FEBRUARY 14, 2019
USC CLASSROOM ENHANCEMENTS 2019
FOR SLOAN 112
PROJECT# 50003348-3,H27-Z341

ADDENDUM #4

Tate –Boltedstringercornerlockcombo.pdf

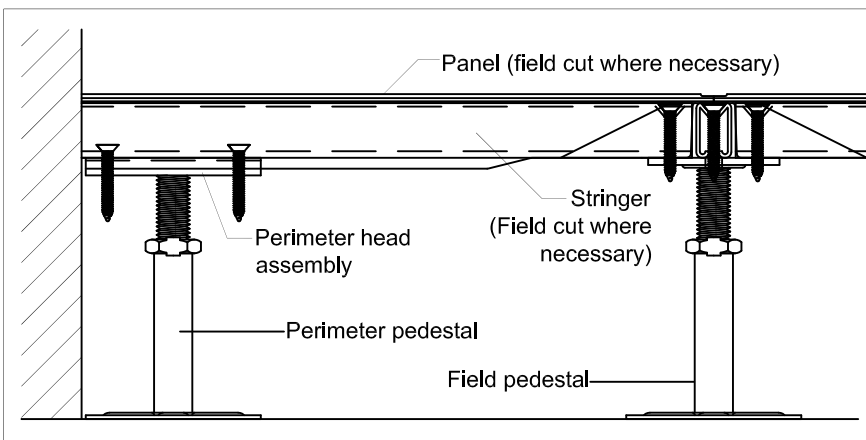
1. Section 09 6900 - ACCESS FLOORING Remove this section in its entirety and replace it with the one attached to this document..

- Assembly up to 36" FFH shall provide a 6,000 lb. axial load without permanent deformation.
- Assembly shall provide a 2" total adjustment with a floor height of 7" or greater.
- Standard finished floor heights from 6" to 36". For other finished floor heights please contact the Tate Technical Hotline @ 800-231-7788. For seismic conditions, refer to seismic submittal details.
- Overturning moment of 1,000 in./lbs. when Tate recommended pedestal adhesive is utilized.
- All pedestal components and fasteners are completely electro-zinc free.
- Zinc electroplating shall be prohibited on all pedestal components and fasteners.

- Standard head is 11 ga. die formed galvanized steel pedestal head and resistance welded stud with adjustment nut. Heavy duty head for CC2000 and CC2500 panels is 8 ga. fillet welded for field and tack welded perimeter head. Head and installed stringers shall provide perimeter support for panel.
- Stringers shall be attached with 1/4" - 20 flat-head screws.
- Pedestal head shall be tapped for engagement of stringer screws.
- Steel stud shall be 3/4" - 10 UNC roll formed.
- Nut shall be 3/4" - 10 UNC with corrosion resistant coating.
- Cornerlock fastener shall be 1/4" - 20 flat-head machine screw.
- Stud shall provide an anti rotation feature when engaged with the pedestal base assembly (7" FFH or higher).

- Base to be at least 16" square and galvanized steel.
- Pedestal tube shall be 7/8" square galvanized tubing.

- Heavy duty roll formed steel stringer will withstand 450 lb. mid-span load.
- ConCore 2500 panels require the 4' x .054" stringer. All other panels except the ConCore 3000 use the .048" stringer
- Galvanized stringer construction to prevent corrosion. Zinc electroplating is prohibited.
- Stringer shall be 1-1/4" deep x 3/4" wide.
- Stringer grid pattern shall be 2'2", 2'4", or 4'1/4".

- Perimeter pedestal shall provide support for panels around columns, at walls, curbs and fascia.
